## City of Keene Minor Project Review Committee

### **AMENDED AGENDA**

**City of Keene**  
**New Hampshire**

**RE: Planning Comments on Site Plan Application  
561 Main St. Redevelopment**

**SITE PLAN**  
**TAX MAP 114 LOT 29**  
**(561 MAIN STREET)**  
**KEENE, NEW HAMPSHIRE**

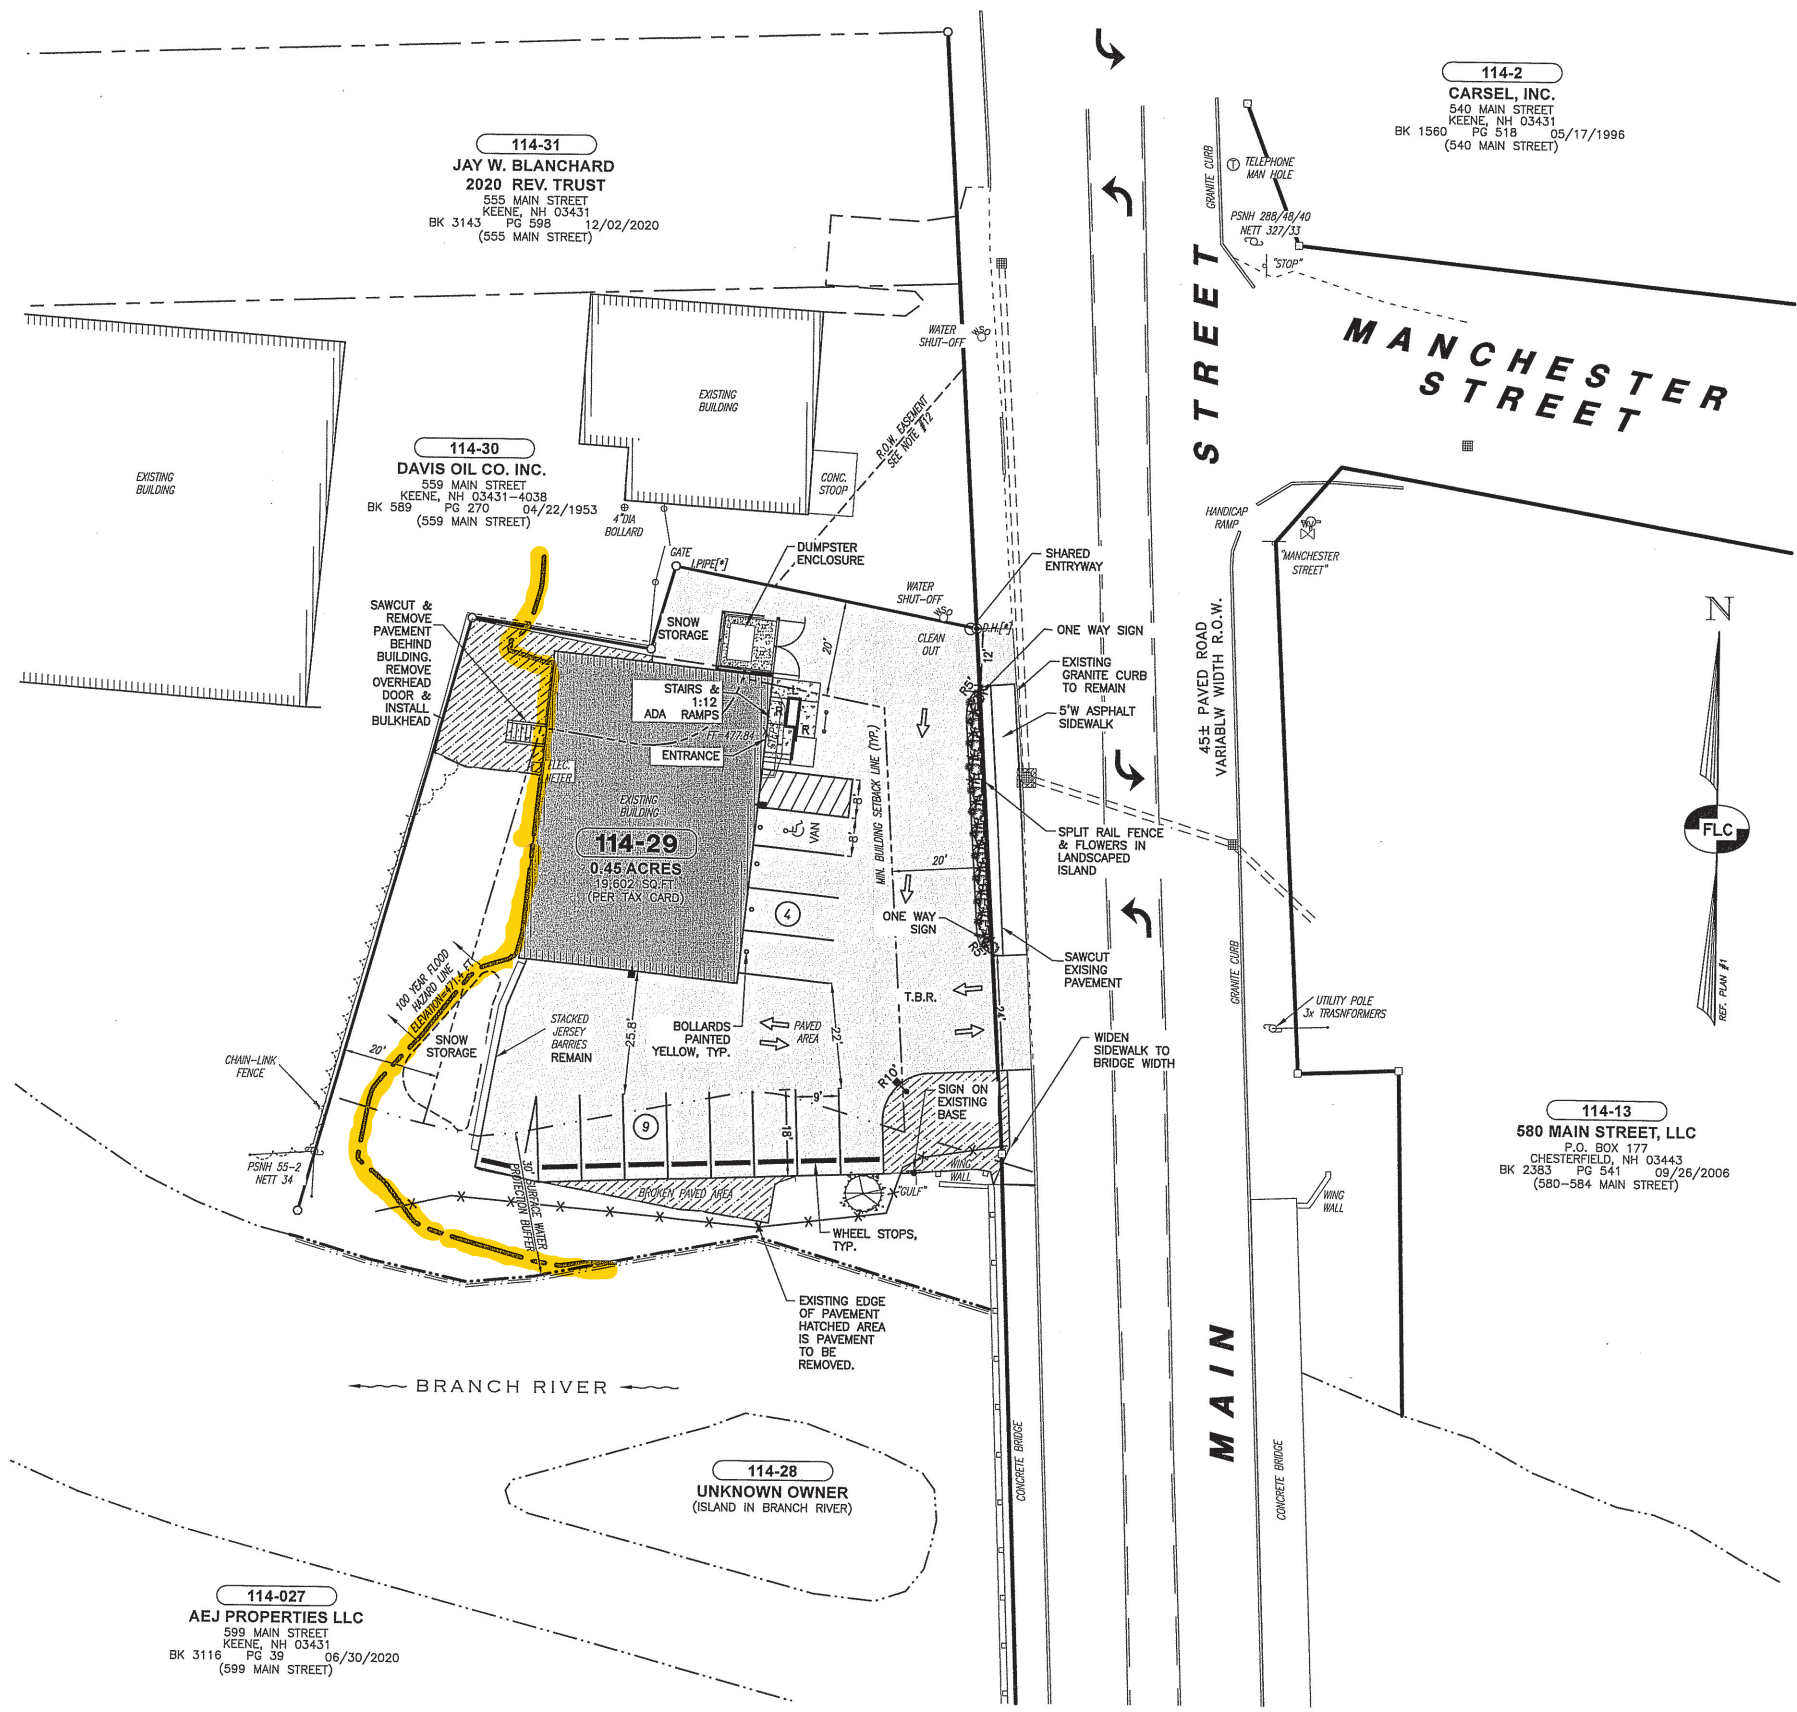
1. Please include the stamp/signature of a NH Licensed Engineer on the submitted stormwater analysis.
2. Please submit a revised plan set that more clearly shows/distinguishes the 100-YR Flood Hazard Line. It is difficult to see this line, especially where it runs in relationship to the building footprint.

4. From aerial imagery, and the note included on the plan, it appears that the existing, northern-most curb cut is shared with the adjacent property at 559 Main St. Will the curb cut/driveway in this area remain open / shared with the adjacent property? Would you please submit copies of the deeds that address shared access for this driveway with the adjacent lot?

5. Will there be any conversion of pervious surface area to impervious surface within the 30-ft Surface Water Protection Buffer area? It is not clear on the site plan where the edge of existing pavement is, compared to where the parking lot area will be installed. If so, this may require a Conditional Use Permit from the Planning Board. Please submit a plan that more clearly defines where new pavement will be installed, if any.

6. There is an area in the northwest corner of the site where pavement is proposed to be removed. Will grass be installed in this area? If so, are there plans to utilize the rear overhead doors for vehicle access?

1. *Please include the stamp/signature...:* A stamped copy of the stormwater analysis is attached.
2. *Please submit a revised plan set that more clearly shows/distinguishes the 100-YR Flood Hazard Line.*  
The Flood Hazard line follows the contour at 471.4' of elevation and terminates at the building wall, technically following the building wall and is shown off the northwest corner. It has been highlighted on the plan. The applicant has decided to fill along the back foundation wall to remove the building basement from the floodplain. This will require a small area of compensatory storage and remapping the floodplain with FEMA with both a Conditional Letter of Map Revision (CLOMR) and a Letter of Map Revision (LOMR).

**LANDSCAPING PLAN**  
**TAX MAP 114 LOT 29**  
**(561 MAIN STREET)**  
**KEENE, NEW HAMPSHIRE**  
 PREPARED FOR:  
**LOGAN GORGULU**  
 17 UNION STREET, KEENE, NH 03431  
 LAND OF:  
**JAMES T. RYMES**  
 P.O. BOX 2948, CONCORD, NH 03302

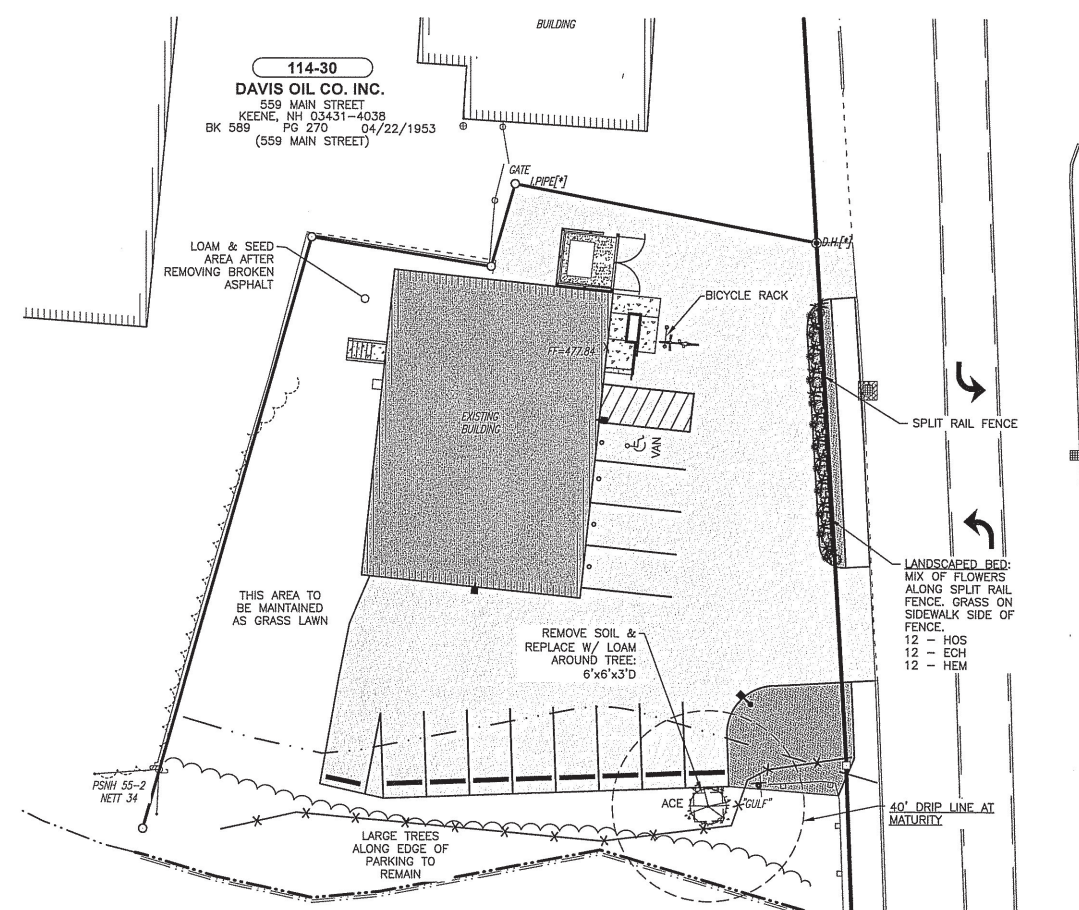
7. Please submit a revised Landscaping Plan that more clearly shows the number and species of plants to be installed along Main St. The table on this plan notes the number and type, however, these species are not indicated on the plan.

7. *Please submit a revised Landscaping Plan ...:* The note and table on the plan have been revised to show how the flowers will be distributed along the landscaped strip, adjacent to the street. There will be an equal number of plants, placed in a repeating pattern along the split rail fence. These plants will be the Hostas, coneflowers, and daylily with twelve (12) of each species. The owner may choose to plant annual flowers in addition to these perennial plants.

5-BIKE WAVE BIKE RACK

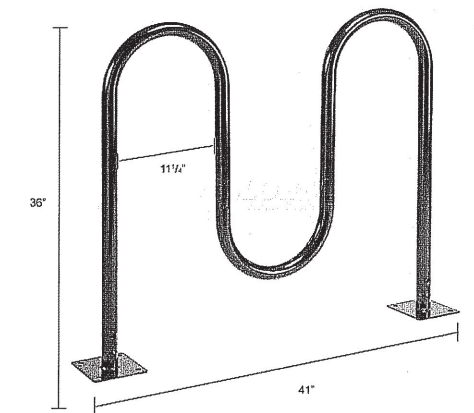
9. Per Standard 20.9.3.E. “For development other than single-family and two-family dwellings, bicycle parking shall be provided in racks or other similar facility.” Please submit a revised plan that displays the installation of a bicycle rack on the site. Bicycle racks cannot be located within parking areas for motorized vehicles.

9. *Per Standard 20.9.3.E. ... bicycle rack on the site.:* A bike rack has been added to site plan, capable of holding 5 bicycles and out of the vehicle travel ways.

DECIDUOUS TREE PLANTING DETAIL

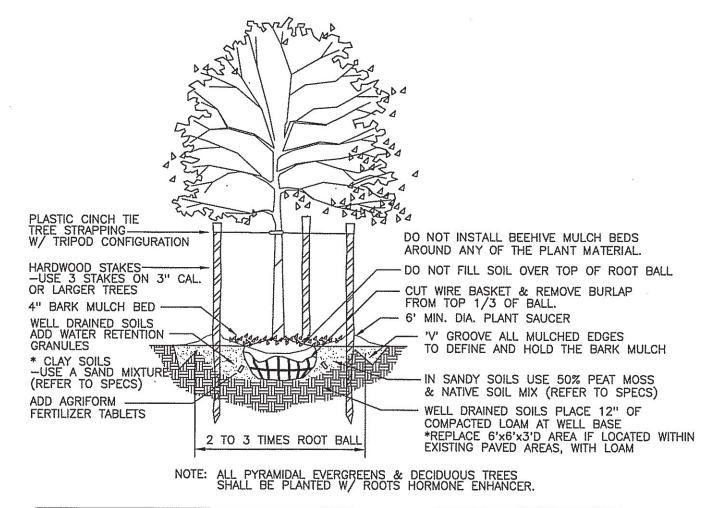
8. Please note that Site Development Standard 20.5.2.C requires that “tree plantings in areas of non-native or compacted soil, the existing soil shall be excavated to enable the placement of 300 cf of native, permeable soil in an area no less than 6-ft wide by 3-ft deep.” Please submit a revised plan that demonstrates compliance with this standard.

8. *Please note that Site Development Standard 20.5.2.C requires...:* A note has been added to remove the existing soil around the tree and replace with suitable soil in a 6'x6'x3' deep area. The plans have been revised to add one tree adjacent to south parking area. There are very large oak and maple trees that exist along the southern paved area that shade the parking lot. The canopies are large enough to overhang the parking lot and they would hinder any new plantings. The one tree meets the landscaping requirement.
